SB TMG 691-1003 P2

Service Bulletin

Subject: Water separator

Type affected: All Diamond DA40 with TAE 125-02-114

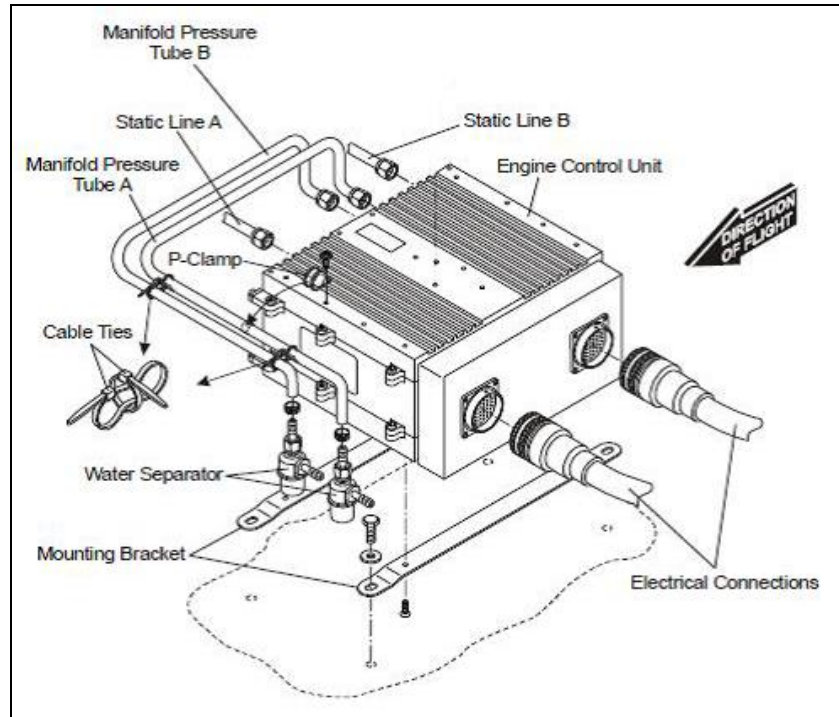
- Remove the pilot seat i.a.w. the original A/C AMM.
- Check if an original water separator system is installed.
See figure below.

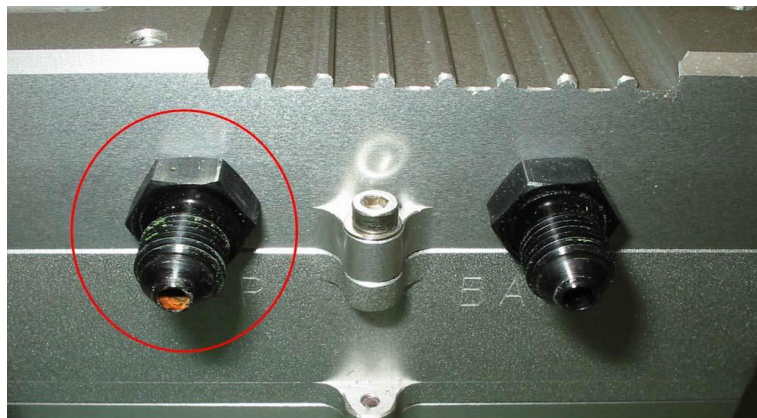
- Remove both MAP lines to check the FADEC fittings.
- Inspect the FADEC fittings on water, water residues, corrosion, sediments etc. Refer to the picture below.

If such damages are detected, the FADEC needs to be replaced.

P/N 50-3940-E0020 03

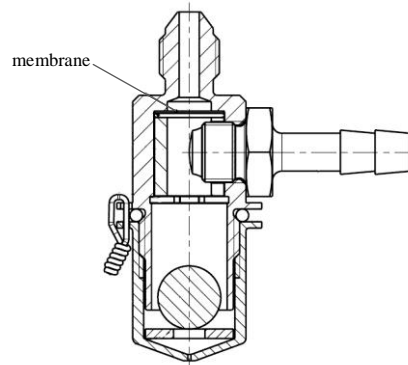
- Disconnect the manifold pressure hose from both water separators.
- Remove both water separators from the manifold pressure tubes.
- Attach both new water separators to the manifold pressure tubes.
- Connect the manifold pressure hoses to the water separators.
